Access Compliance Report

Public Rights-of-Way (Curb Ramps)

Intersection ID: 27563	Main Street: BALLANTYNE_FOREST_DR	Cross Street: LEDERER_AV	Location: SW
ADA ID: 92C2E3E6EF45	Ramp Type: Perp	Initial Pass/Fail: Fail	Overall Compliance: No
Codes/Mitigation Info/Possible Solution		Field Measurements/Component Compliance	
Severity Score: 21.25

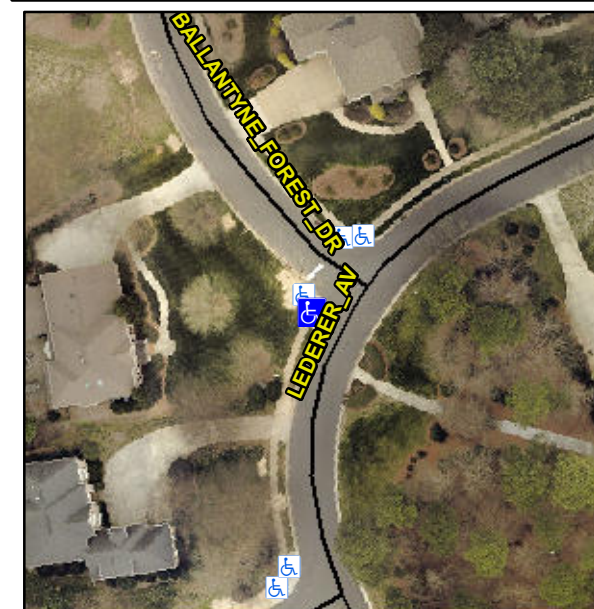
Not Found, R304.5.1, R304.2.2

Compliance	Description	Data	Compliance	Description	Data
N/A	Ramp Length (in)	46.0	No	Ramp Slope (%)	8.4
No	Ramp Width (in)	42.0	Yes	Ramp XSlope (%)	0.5
N/A	Flare Type LT	N/A	N/A	Flare Type RT	N/A
N/A	Flare Slope LT (%)	N/A	N/A	Flare Slope RT (%)	N/A
N/A	Flare Traversable LT?	N/A	N/A	Flare Traversable RT?	N/A
N/A	Landing Length (in)	N/A	N/A	DWS Provided?	N/A
N/A	Landing Width (in)	N/A	N/A	DWS Contrast?	N/A
N/A	Landing Slope (%)	N/A	N/A	DWS Length (in)	N/A
N/A	Landing X Slope (%)	N/A	N/A	DWS Full Width?	N/A
N/A	Landing Curb? (Y/N)	N/A	N/A	DWS Offset (in)	N/A
N/A	Shared Landing?	N/A			
N/A	Gutter Ponding?	N/A	N/A	Gutter Slope (%)	N/A
N/A	Gutter Lip Ht (in)	N/A	N/A	Gutter X Slope (%)	N/A
N/A	Painted X Walk1?	No	N/A	Painted X Walk2?	N/A
	X Walk 1 Direction	To SW		X Walk 2 Direction	N/A
N/A	X Walk 1 Width (in)	N/A	N/A	X Walk 2 Width (in)	N/A
	X Walk 1 Slope (%)	3.6		X Walk 2 Slope (%)	N/A
	X Walk 1 X Slope (%)	1.2		X Walk 2 X Slope (%)	N/A

Remove & Replace Entire Ramp.
